## Committee of the Whole

AGENDA NO. 08/08

## **2 MACQUARIE PARK CORRIDOR – ADOPTION OF REVISED PLANNING DOCUMENTS**

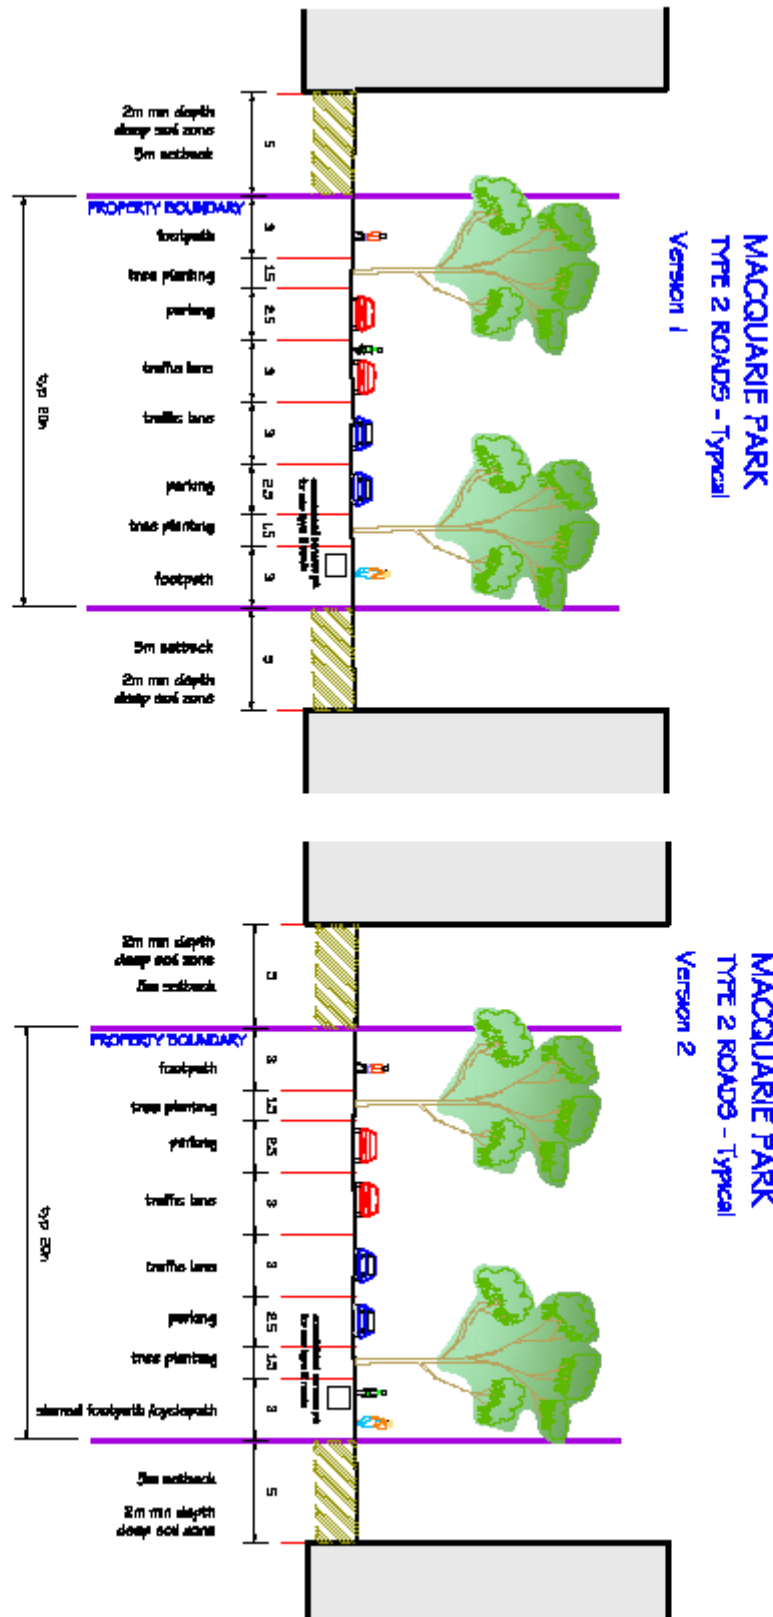
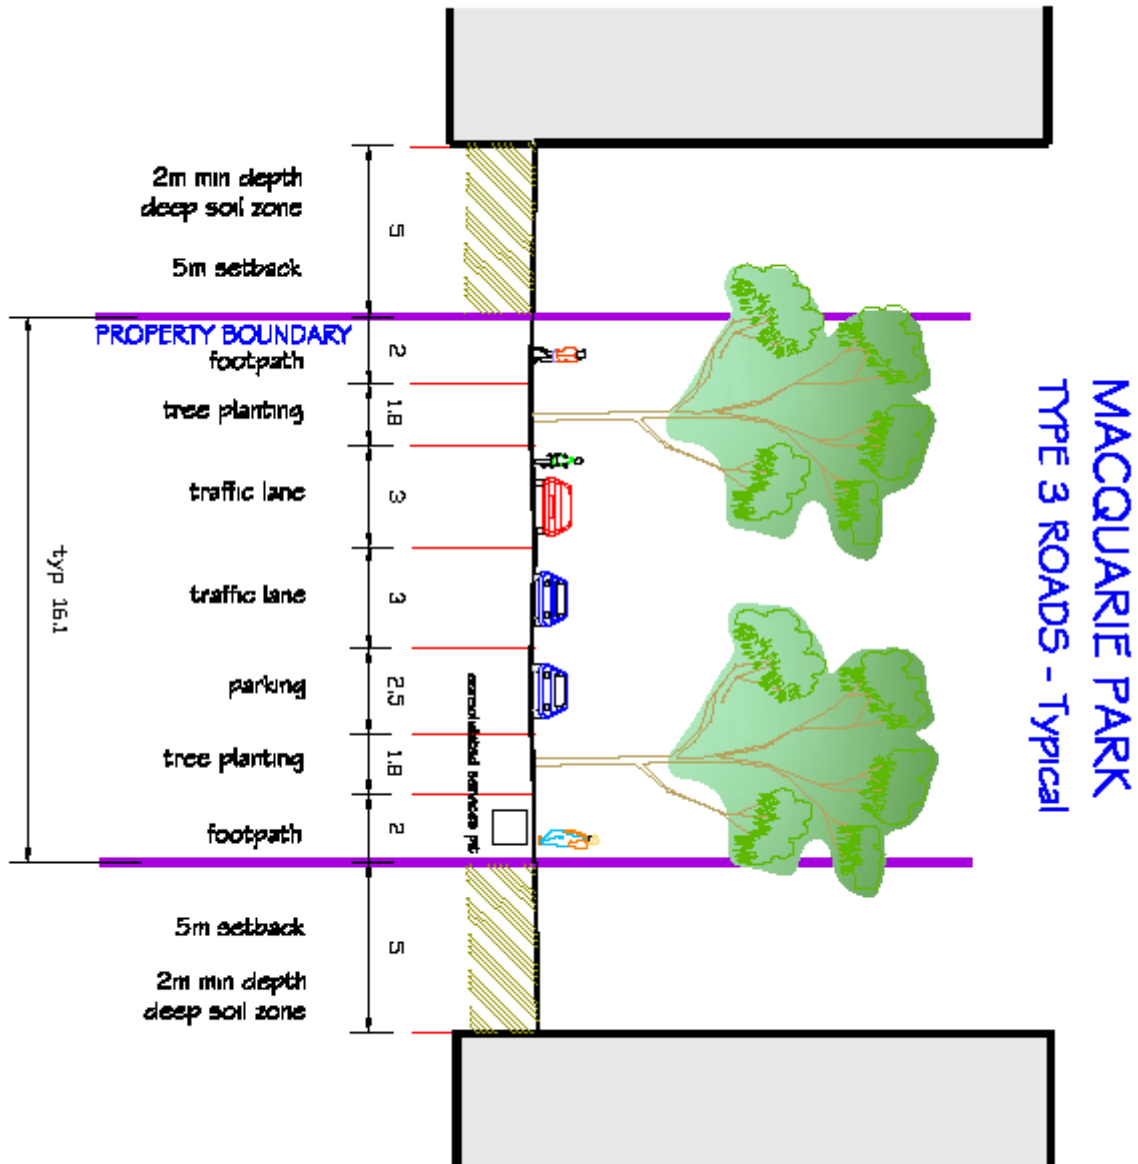
<b>D3.1 Cycle strategy</b>	<ul style="list-style-type: none"> <li>• Amend some aspects of cycle network, as illustrated in attached sketches and as per Attachment 2.</li> <li>• Amend DDCP to include a Signage Plan for Macquarie Park as a community benefit.</li> <li>• Amend DDCP to include references to Ryde Bicycle Strategy and Master Plan 2007</li> <li>• indicate improved connections from Epping Road to Shrimptons Creek cycling path</li> <li>• indicate improved cycleways along Epping Road (show Epping Road as a Type 1 road and text based controls)</li> </ul>
<b>D3.2 Street furniture, paving and lighting</b>	<ul style="list-style-type: none"> <li>• NOTE: incorporate changes to public Domain Manual as outlined in attached "submissions summary table and recommended responses – 15.5.08"</li> </ul>
<b>D3.4 Community Facilities</b>	<ul style="list-style-type: none"> <li>○ Remove reference to CoR Community Facilities Plan (2008/10) as it is not yet finalised and publicly available</li> </ul>

# MACQUARIE PARK TYPE 4 ROADS - Typical

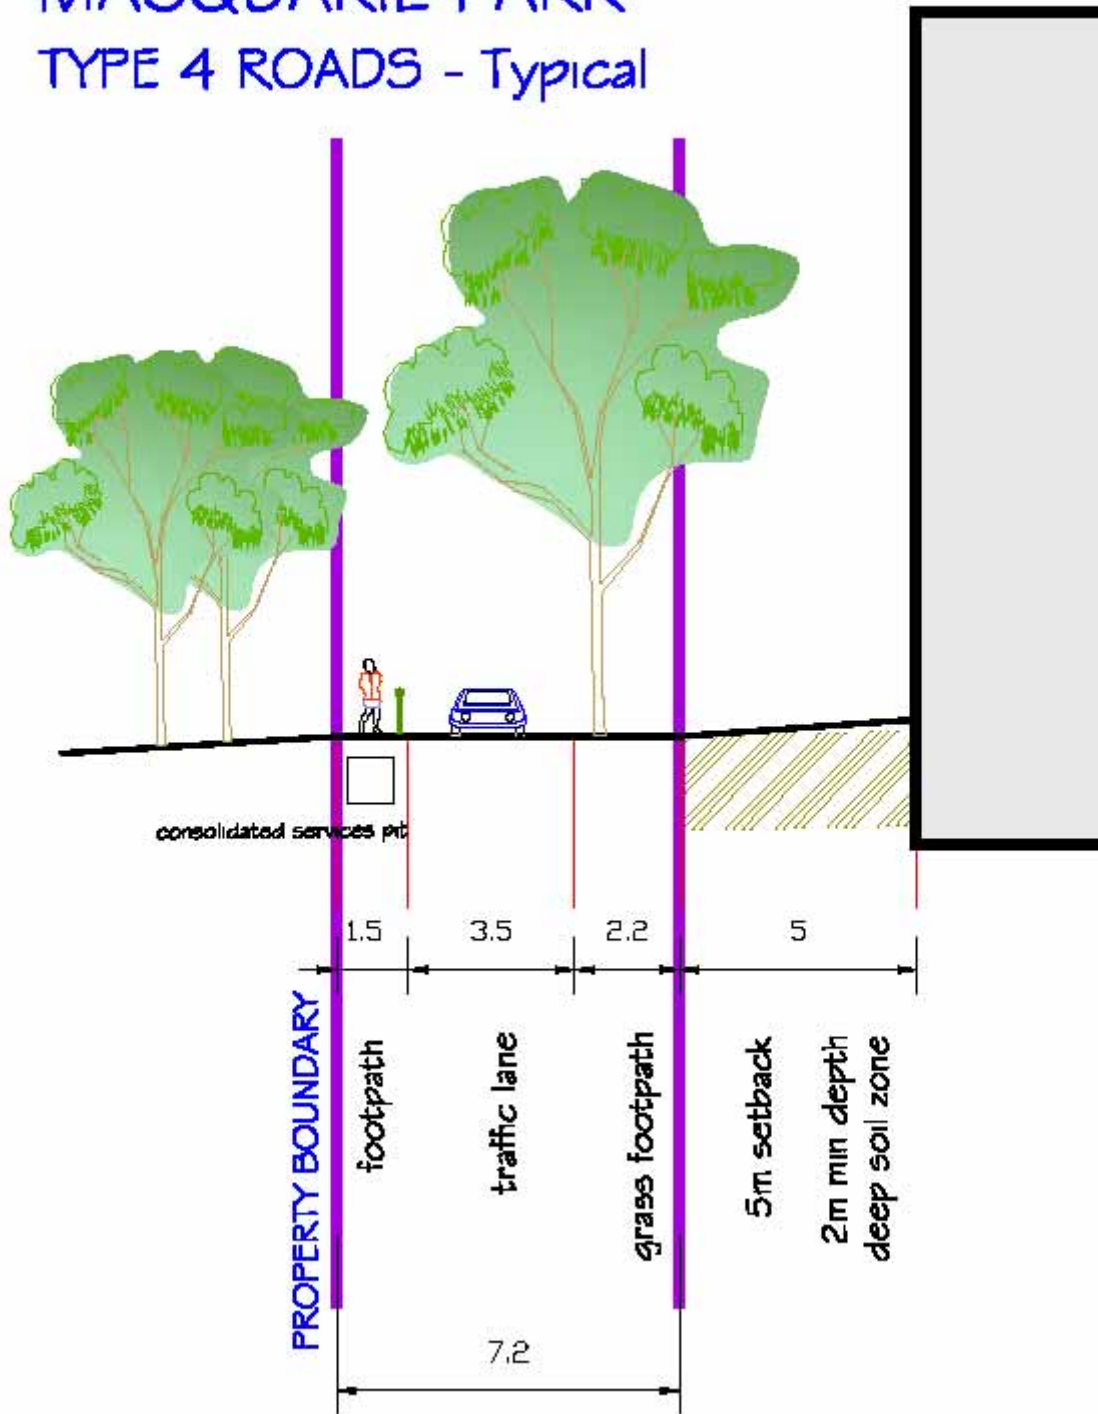
<b>DDCP section</b>	<b>changes</b>
<b>D1 streets</b>	<ul style="list-style-type: none"> <li>• Ensure detailed roads network plans in section D.1 are consistent with Street Network Structure Plan</li> <li>• Amend all street sections as per sketches attached. Notations accompanying drawings are: <ul style="list-style-type: none"> <li>• Street trees on Type 1 streets are to be located in the front setback to avoid conflict with underground services. Native tree species to be specified</li> <li>• New roads to have shared services pits to reduce conflict with street tree roots and minimise maintenance costs.</li> </ul> </li> </ul> <p>NOTE: there will be consequential changes to the Public Domain Manual to ensure consistency with the revised Street Sections and minor clarifications.</p>
<b>D2 public open space</b>	as per B1 and C1 above
<b>D2.4 Porters Creek</b>	<ul style="list-style-type: none"> <li>○ Rename Wick Road Reserve</li> <li>○ Add notation to Open Space Network Structure Plan to indicate that the network between Wicks Road and the M2 will be subject to detailed design and the outcomes of a Water Sensitive Urban Design Strategy</li> </ul>
